**APB5 - Replacing the Cell Block Module on High-Voltage Battery (Recall Campaign)**

Vehicle Type: **Taycan (Y1A / Y1B / Y1C)**

Concerns: **Cell block module**

*Installation position: Cell block module*

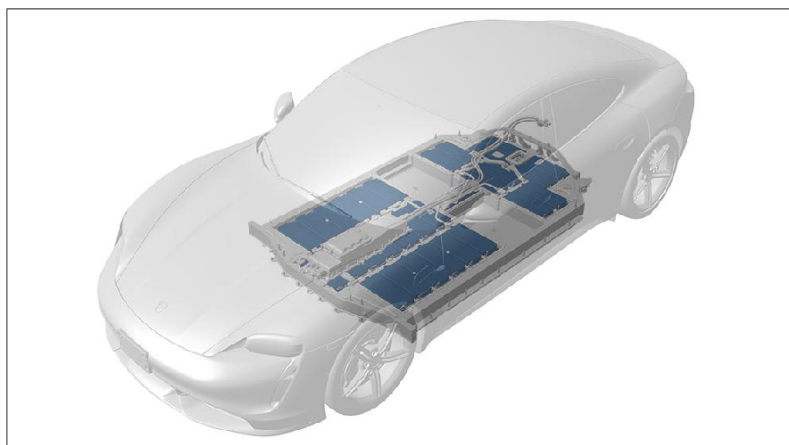
Cause: **There is a possibility that, under certain circumstances, a defect in the battery cells installed in the high-voltage battery can occur on the affected vehicles.**

In this case, a short circuit within the battery modules during the vehicle's service life cannot be ruled out, which could lead to thermal events and later to a fire in the vehicle.

Action: Replace cell block module.
